AUTUMN ACRES

PHASE 1 PLAN REVISION 1 MARCH 2022

V1_Sketch Plan Drawings.pdf Markup Summary 2-22-2023

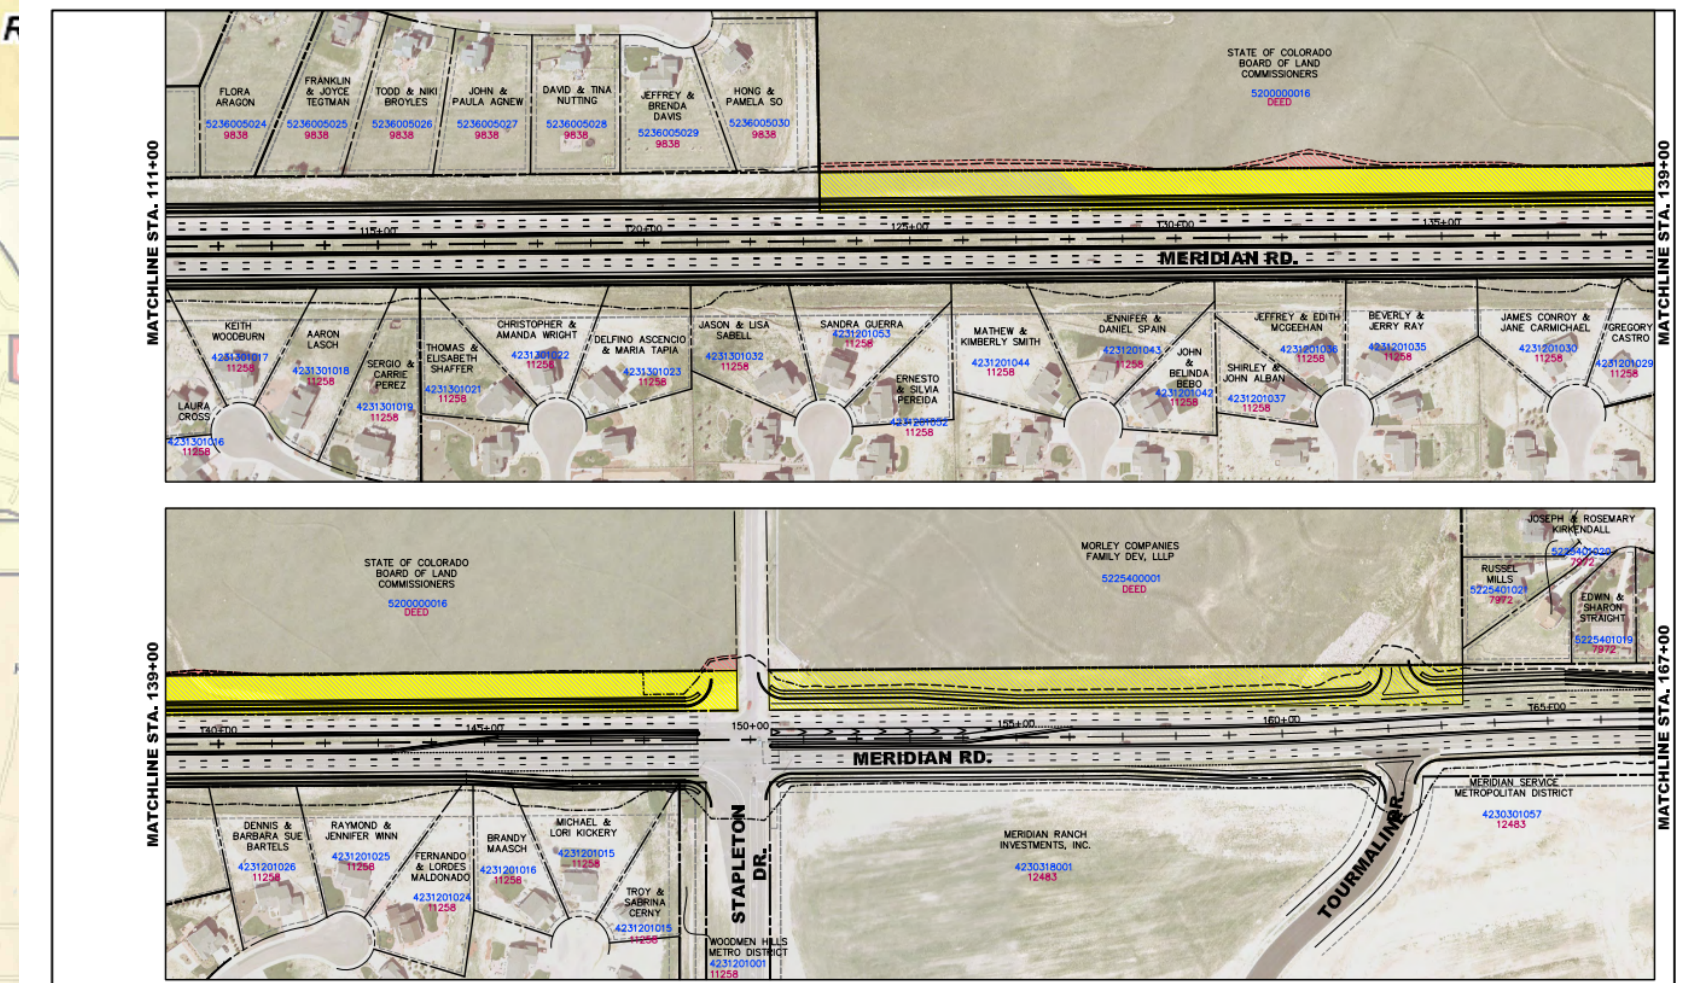
Identify proposed ROW dedication along Stapleton. The current Stapleton corridor plan that is currently in progress identifies a 168' ROW width for Stapleton.

Depict the utility landuse area for the Sanitary lift station and other components.

Provide a deviation request for intersection spacing as a principal arterial requires 1/2 mile spacing.
Add a general note that the full movement access will change to a RIRO with future widening of Stapleton Road in accordance with the Stapleton-Briargate corridor access control plan.

identify as full access in instead roundabout

As noted during the early assistance meeting this access does not meet intersection spacing criteria and will not be approved. Remove proposed access location.

landscape setback required along major arterials outside of dedicated row- depict as buffer /landscape setback

Existing Meridian Road is currently within the property. Provide additional ROW per the Meridian North Corridor Plan. See area highlighted in yellow for additional ROW.
Control Plan study is available at <https://publicworks.elpasoco.com/road-bridge-planning/>

depict trails per 2023 Parks Master Plan

Show the existing ROW along the east side of Meridian Road.

only show the collector roads and arterials; w access points at key intersections; a sketch plan does not set roads. Please, remove local roadways; remove the zoning from the plan and identify density and landuse, transitions, buffers etc. Please look at SKP 223, SKP224; SKP 225; SKP201; for examples of what is to be depicted and typical notes. A phasing plan can be eliminated if notes are depicted on SKP that anticipated phasing is XYZ; subject to change without a skp amendment being required

depict roadway line work for Meridian and Stapleton. Identify any dedication that will occur based on TIS

As noted during the early assistance meeting this access does not meet intersection spacing criteria and will not be approved. Remove proposed access location.

Clearly delineate bubbles for density and land use.

Add note that states that the proposed streets and access locations are conceptual and subject to change. Deviation requests must be approved for transportation and access design that is not in conformance with the EPC Engineering Criteria Manual Standards.

remove future or proposed- this is a sketch plan which is setting the future, key access points, density and land use categories

remove the self storage label and put commercial;

this area should be depicted as open space as its not suitable for LOT MIX structures

Please set up a legend to show trails, open space, ponds, density various landuse categories etc as istypical on SKP submitted

dimension buffers

See Engineering Criteria Manual (ECM) chapter 2 for roadway design criteria. Maximum cul-de-sac length is 750 ft for urban condition.

place the areas to be preserved in open space- this would cause significant concern with Criteria for approval depicting much of the site w water shallow- decide what areas will be preserved.

Show and Identify access to Theriot Road

Is there a residential unit density cap based on water? what is the cap square footage on commercial?

Depict there trail connectivity throughout the site (use notes to state internal sidewalks will connect the trails shown) please

Please categorize and match the Code definitions and use tables; Single-family attached, single family detached, commercial; multi-dwelling etc- see checklist

ZONING MAP

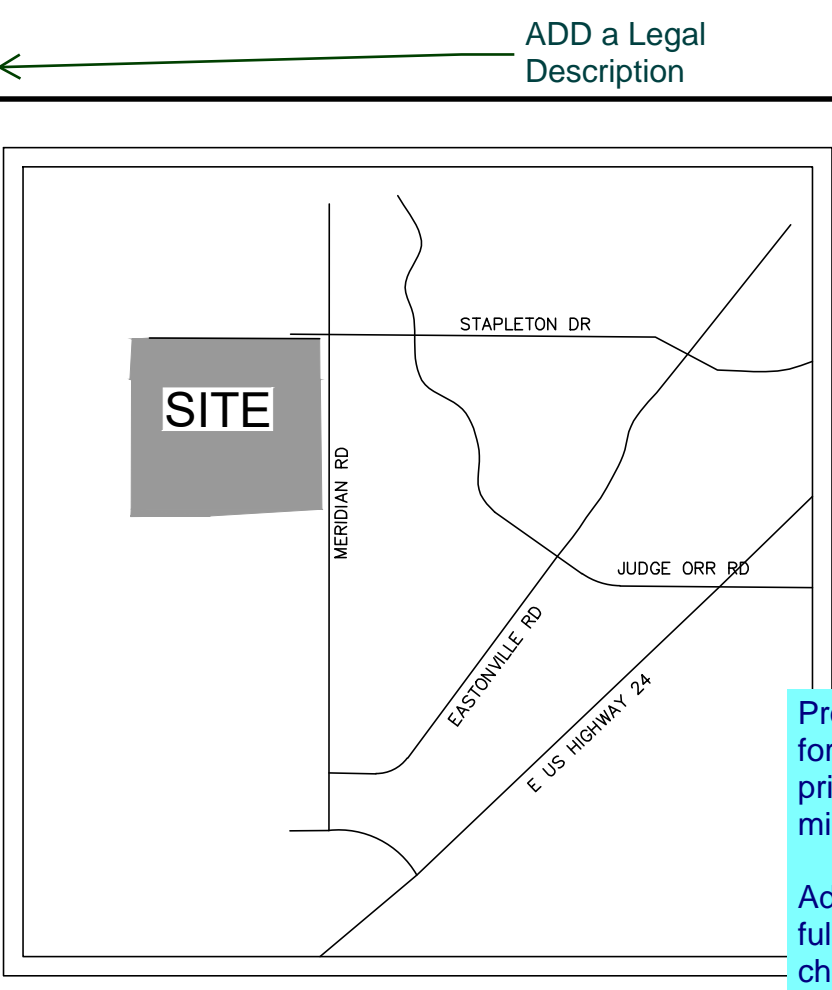
the zoning map changes quarterly; label the zoning, aj lot lines roads and adj property info per the checklist please.
